Proposed Preschool & Primary School, at 1 Rosemead Road, in Hornsby, NSW

Traffic impact and parking assessment study

February 2020

A group of the local residents

Figure 2.1: Road hierarchy

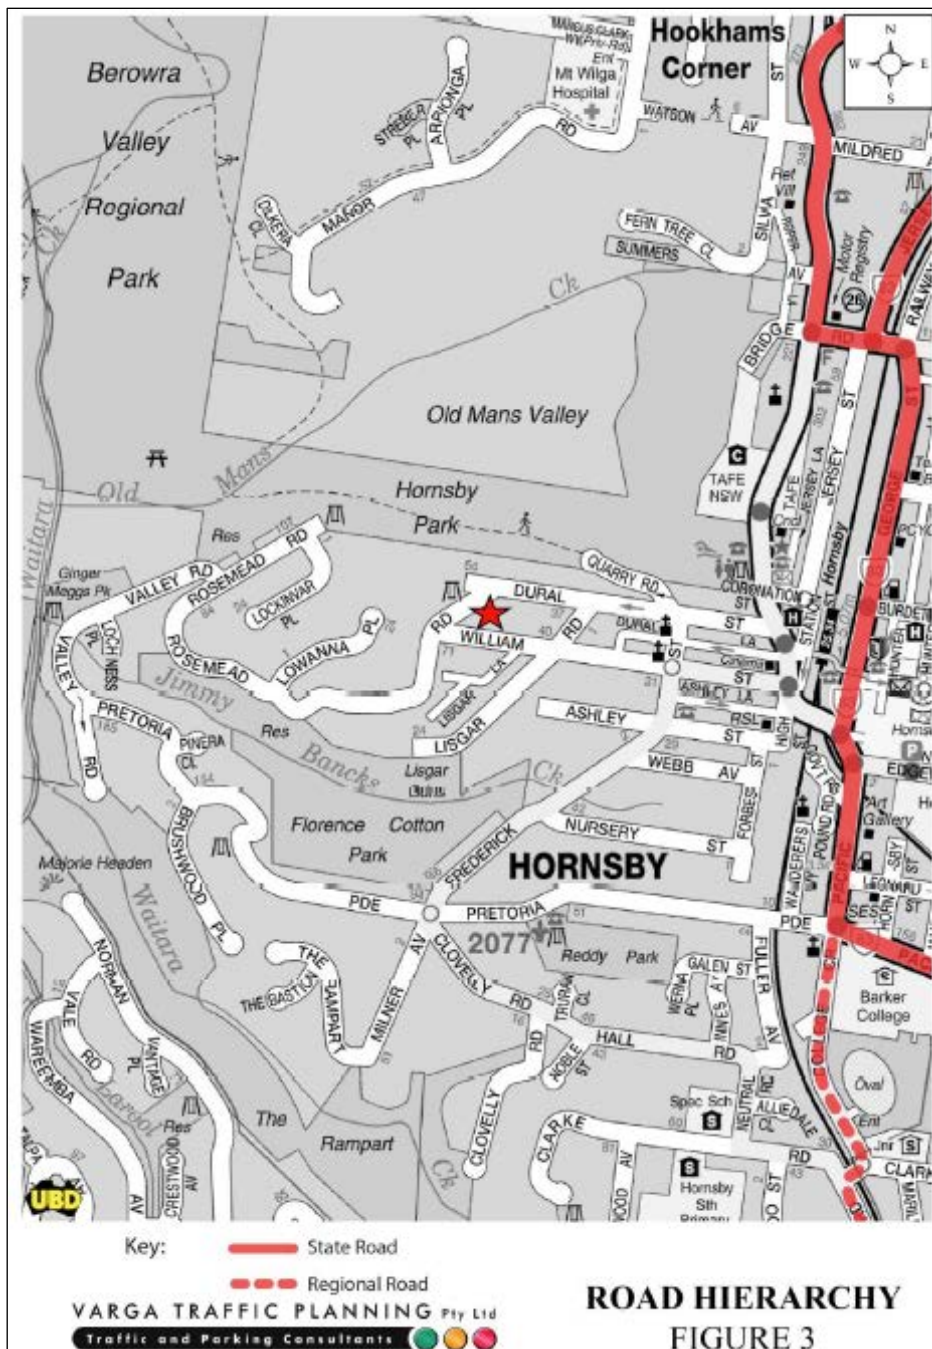
In all likelihood and foreseen circumstances, the vast majority of vehicles generated by the proposed development would utilise the Peats Ferry Road / William Street intersection to turn into William Street on their way to the school. As shown in Figure 2.1, Dural St is one-way for westbound traffic between Quarry Rd and Lisgar Rd. Therefore, Dural St would get very little use by persons travelling to the proposed school.

Figure 3.1
 (Source: nearmap)

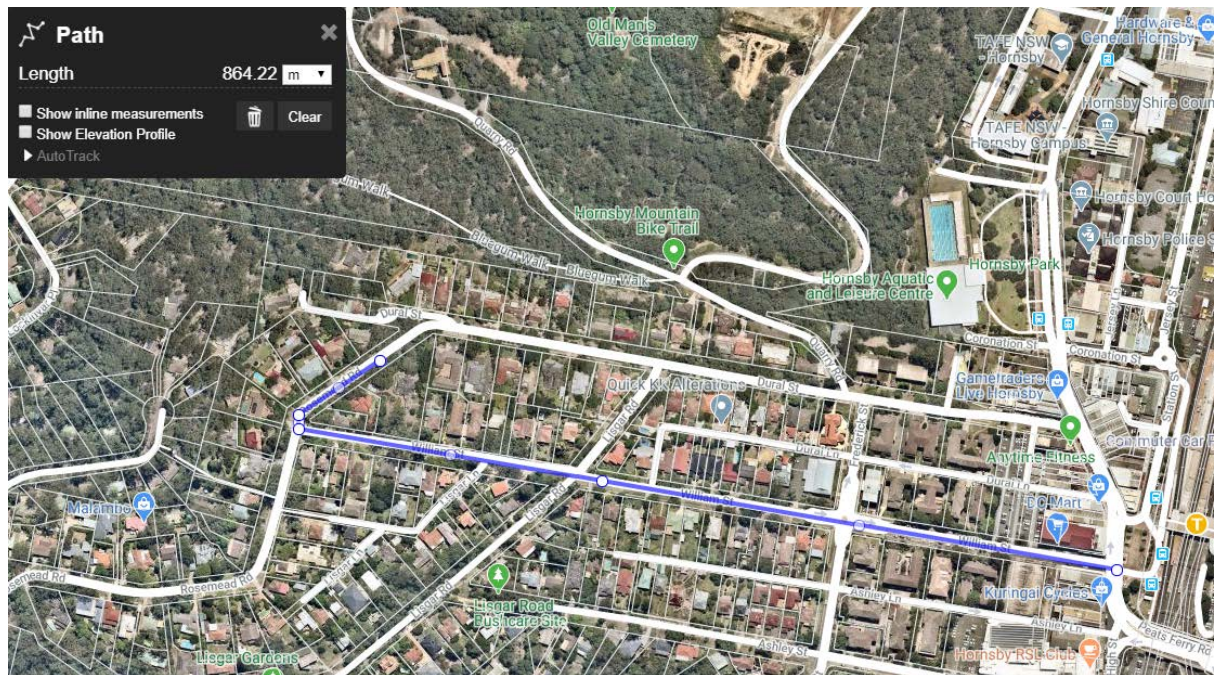
Based on the measurements from the 'nearmap', the Hornsby railway station and bus stops are located approximately more than 850m and 775m east of the site, along William Street and Dural Street, respectively (refer to Figures 3.1 & 3.2).

We are of the opinion that this is not an acceptable walkable distance, as, typically, people are **not** willing to walk such a [quite substantial] distance with their children.

Figure 4.2

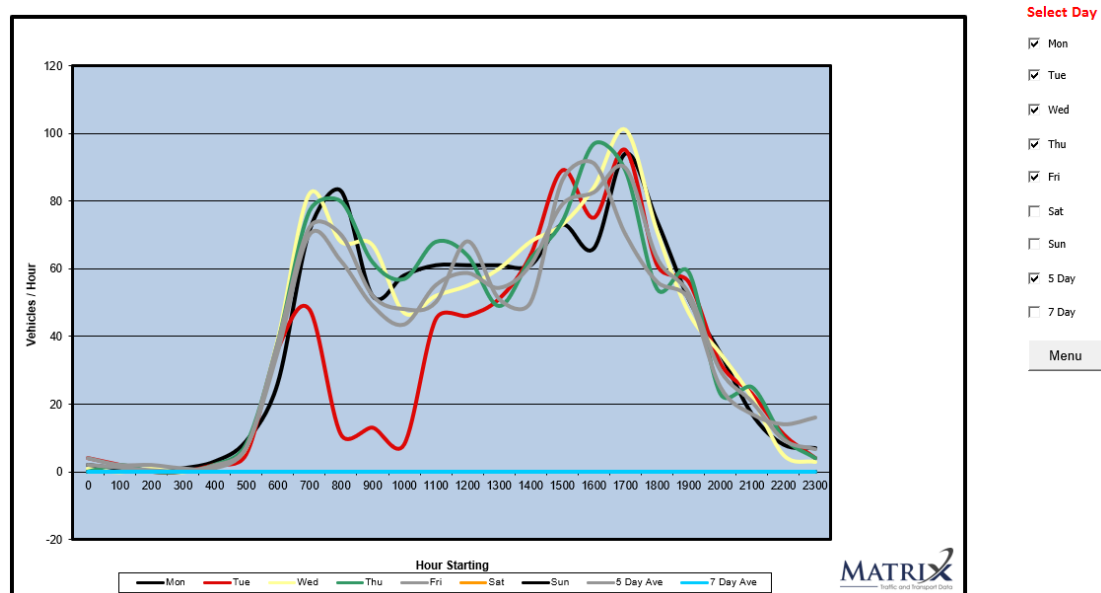
- on the weekdays, morning peak traffic hours occurred between 7:00am and 9:00am, while, in the afternoon, traffic volumes peak between 3:00pm and 6:00pm;
- on average, between 7.00am and 8.00am, and between 8.00am and 9.00am, there were 75 and 75 vehicles, respectively, after ignoring results for the Tuesday, when the road was closed in the morning to remove storm debris (7.00am - 8.00am is $(71+82+77+72)/4 = 75.50$ and 8.00am - 9.00am is $(83+68+80+70)/4 = 75.25$).
- on average, between 3.00pm and 4.00pm; between 4.00pm and 5.00pm; and between 5.00pm and 6.00pm, there were 79; 83; and 90 vehicles;
- the 85th percentile speed [aka 'operational speed'] was in the order of 35.4km/h.

Figure 4.3

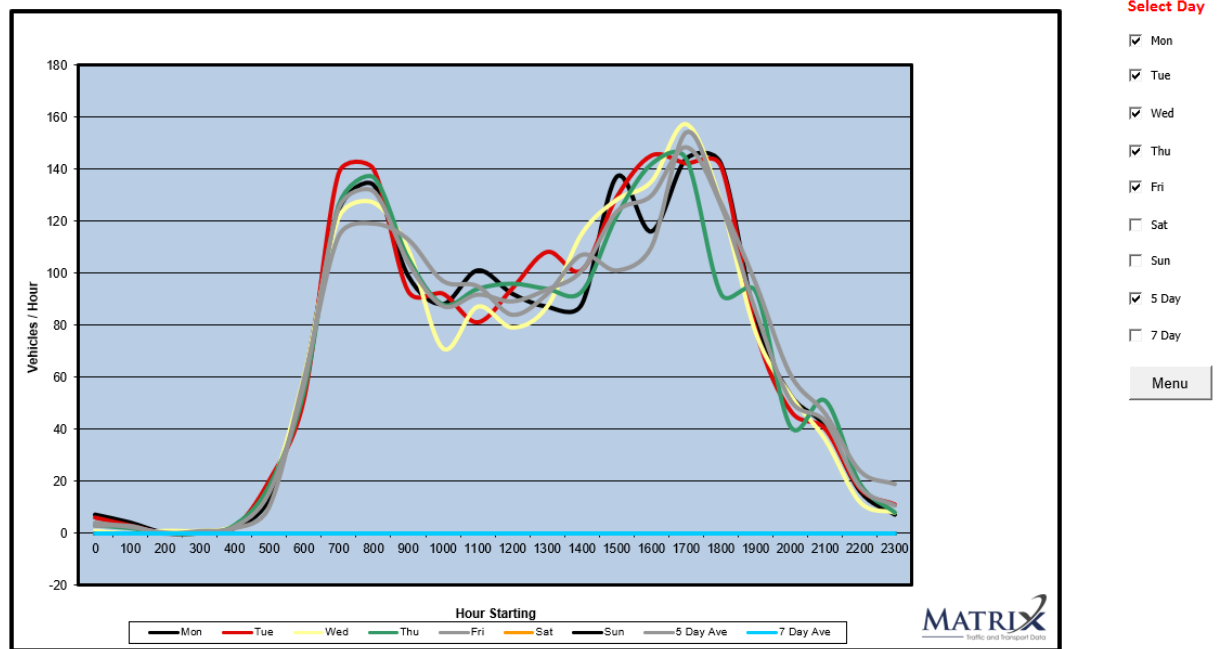
- on the weekdays, morning peak traffic hours occurred between 7:00am and 9:00am, while, in the afternoon, traffic volumes peak between 3:00pm and 6:00pm;
- on average, between 7.00am and 8.00am, and between 8.00am and 9.00am, there were 125 and 131 vehicles, respectively;
- on average, between 3.00pm and 4.00pm; between 4.00pm and 5.00pm; and between 5.00pm and 6.00pm, there were 123; 130; and 148 vehicles;
- the 85th percentile speed [aka 'operational speed'] was in the order of 42.1km/h.

Figure 7.2: Car stopping sight distance

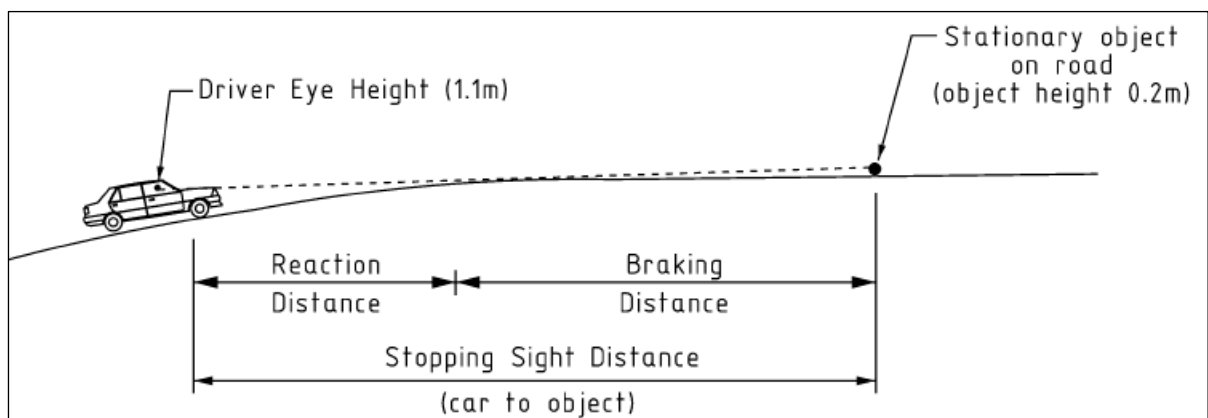
In other words, introduction of, on average, at least 71 ingress vehicles' turning movements at the proposed location for the entry driveway [where, currently, the existing driveway is] would significantly increase the chance for severe crossing turning collisions to occur as result of the fact that even an alert approaching driver, travelling at the speed limit, may not have enough time or distance to perceive, react and brake to a stop before reaching a turning vehicle on the road ahead, at the entry to the subject site (refer to Figure 7.2).
